Groundwater Transfer Review Summary Form

Transfer/PA # T- 14441

Application: T-14441

Applicant Name: City of Bandon

Figure 1

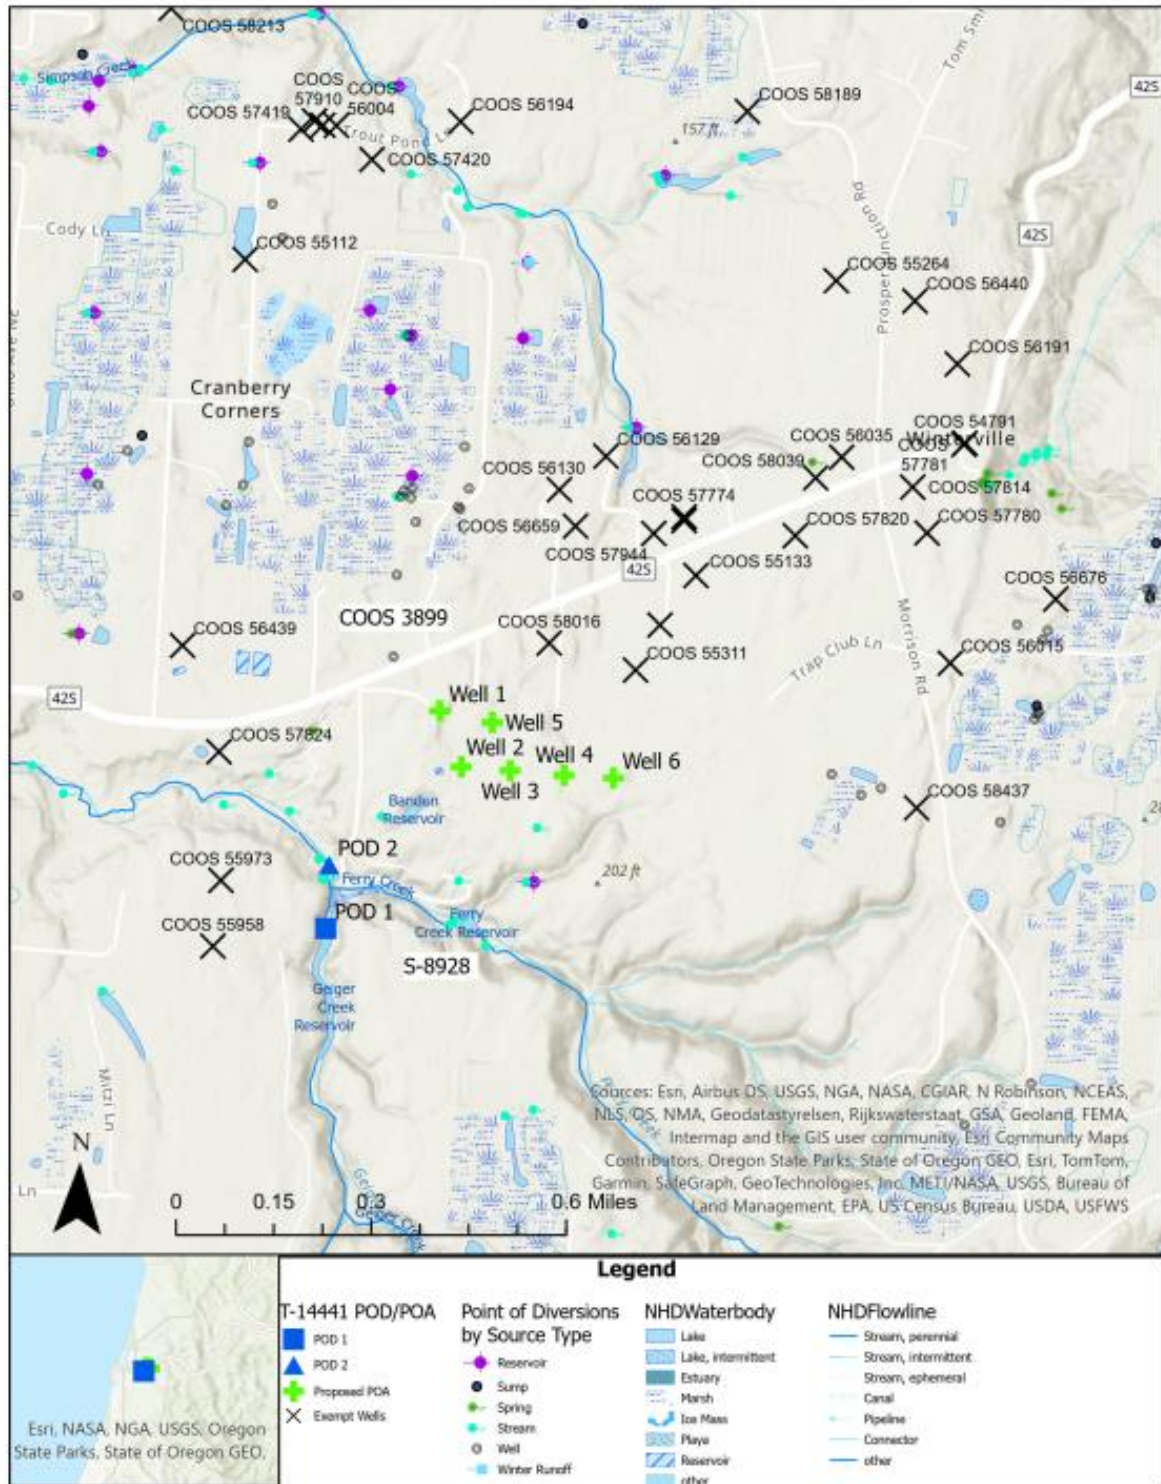
Comments: POD 1 is a diversion from Geiger Creek Reservoir (Figure 1). POD 2 is a diversion from Ferry Creek below the confluence with Geiger Creek, which enters Ferry Creek from the south. The proposed POAs will source water from the unconsolidated sands and gravels of the Pleistocene aged Pioneer marine terrace sediments north of Ferry Creek (sediments). The thickness of the sediments appears to be approximately 60 to 100 feet thick with a saturated thickness of approximately 30 to 50 feet in the vicinity of the proposed well field based on nearby well logs. Static water levels in sedimentary wells near the proposed POA tend to have static water levels that closely match the elevation at which water is first encountered when drilling indicating that the sedimentary aquifer is unconfined in the vicinity of the proposed POA.

Figure 2

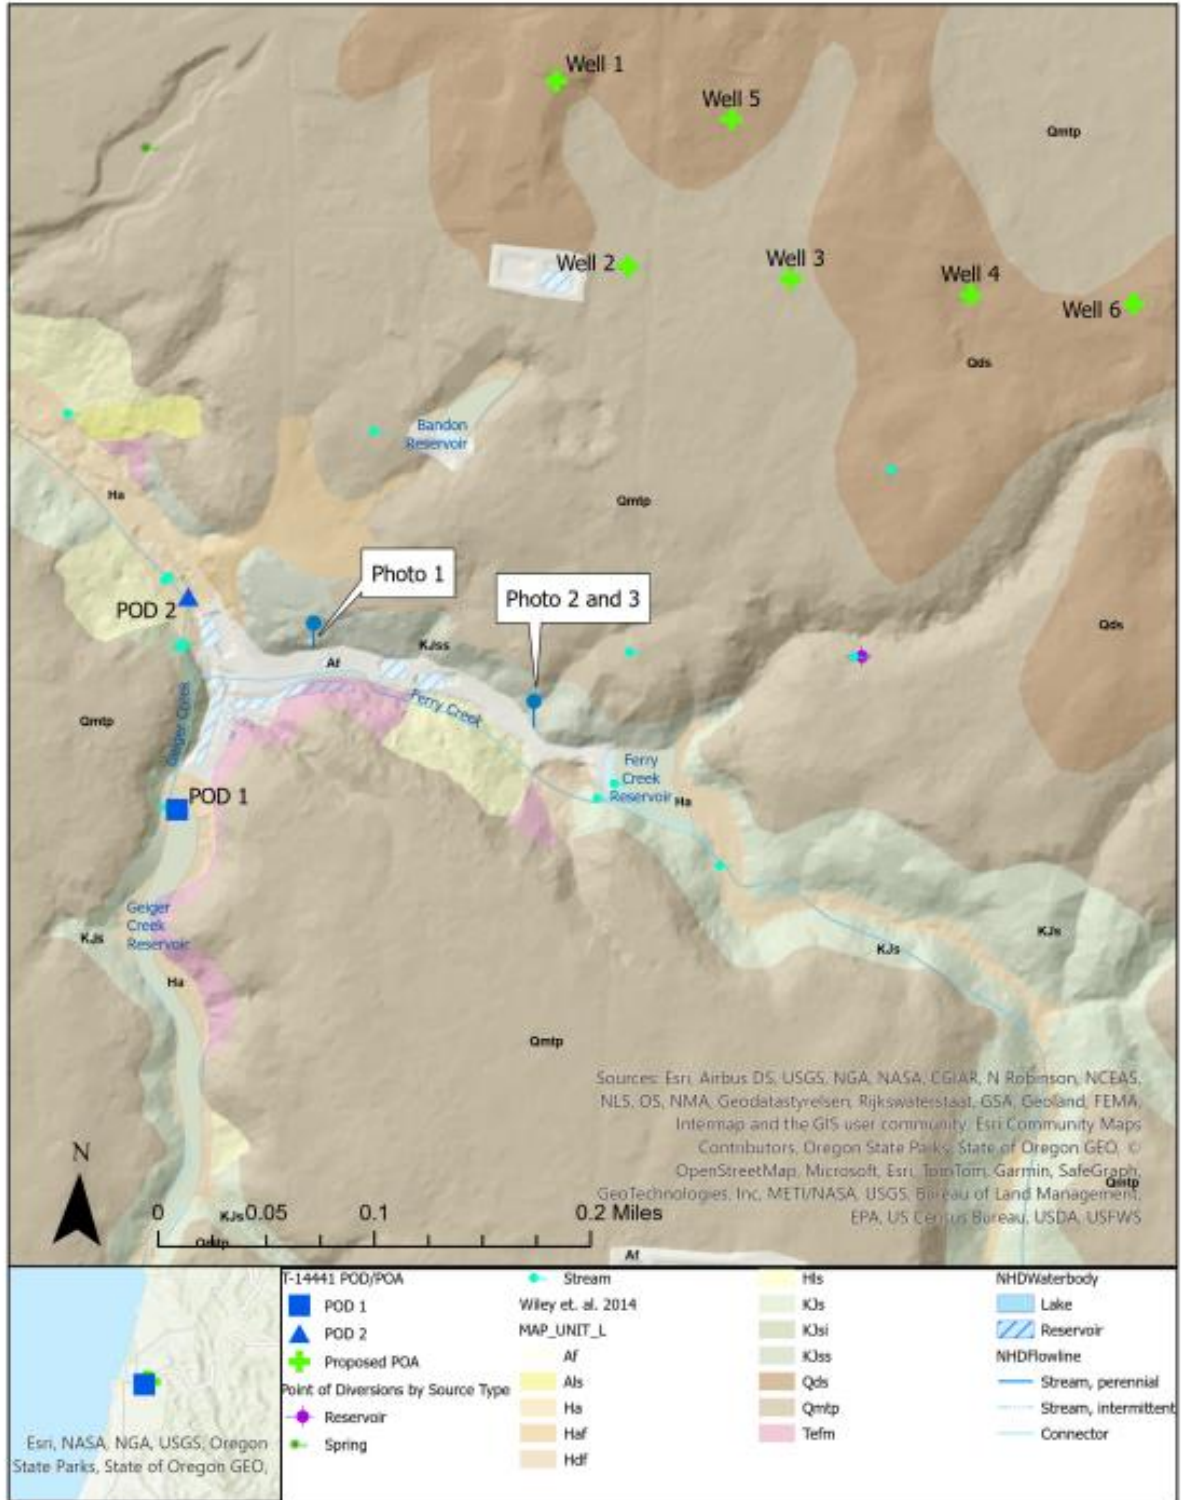
The sediments are underlain by Cretaceous to Jurassic aged mélange of the Sixes River terrane that constitutes the bedrock of the area (bedrock, Wiley et. al., 2014). This underlying bedrock is expected to be much less permeable than the sediments. Mapped outcrops of the bedrock along Ferry Creek indicate that the stream has incised through the sediments, and the sedimentary aquifer is not hydraulically contiguous across the stream. This suggests that the proposed POAs would not source water from the same aquifer as POD 1 on Geiger Creek.

Photo 1: Sandstone bedrock observed at the base of the hill side north of Ferry Creek

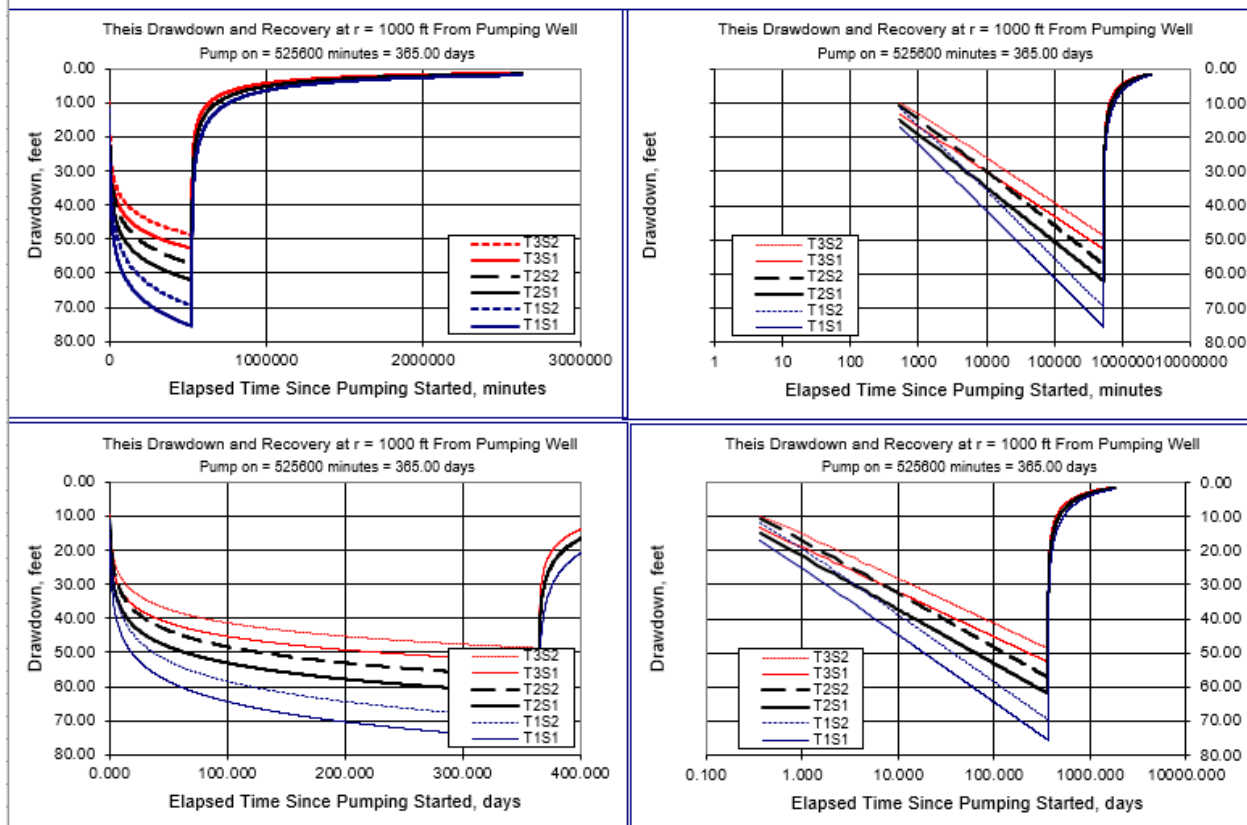
As part of this technical review, the reviewer conducted a site visit on July 18, 2024 to make field observations. An outcrop of sandstone bedrock was observed near the base of the hillside north of Ferry Creek during a site visit (Photo 1) matching the geology as mapped in Wiley et. al. Additionally, water was observed flowing down a ravine on the north side of Ferry Creek into a PVC intake pipe that discharged to the creek (Photo 2 and 3). This observation suggests that groundwater is discharging further up the hillslope, possibly from the contact of the marine terrace deposits and bedrock, and traveling subaerially to Ferry Creek.
